# UNITED STATES PATENT AND TRADEMARK OFFICE

APPLICATION NO.	FILING DATE	FIRST NAMED INVENTOR	ATTORNEY DOCKET NO.	CONFIRMATION NO.
10/588,625	08/04/2006	Chojiro Kuriyama	10921.422USWO	7233
52835	7590	03/30/2009	EXAMINER	
HAMRE, SCHUMANN, MUELLER & LARSON, P.C.			SINCLAIR, DAVID M	
P.O. BOX 2902			ART UNIT	
MINNEAPOLIS, MN 55402-0902			PAPER NUMBER	
			2831	
			MAIL DATE	
			DELIVERY MODE	
			03/30/2009	
			PAPER

<b>Office Action Summary</b>	<b>Application No.</b> 10/588,625	<b>Applicant(s)</b> KURIYAMA, CHOJIRO	
	<b>Examiner</b> DAVID M. SINCLAIR	<b>Art Unit</b> 2831

## **DETAILED ACTION**

Figure 1: Altered version of Arai '534 fig. 6C showing examiner labels

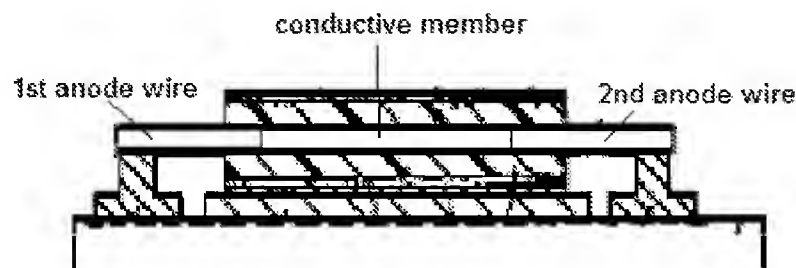
A solid electrolytic capacitor comprising a porous sintered body of valve metal (6 – fig. 6; [0050]); a first and a second anode wires partially extending into the porous sintered body (present office action fig. 1 (POA1); [0050]), portions of the first and the second anode wires which project out from the porous sintered body serving as a first and a second anode terminals; and a cathode including a solid electrolytic layer formed on a surface of the porous sintered body ([0050]);

The solid electrolytic capacitor according to claim 1, further comprising a conductive member for electrically connecting the first and the second anode terminals to each other (POA1).
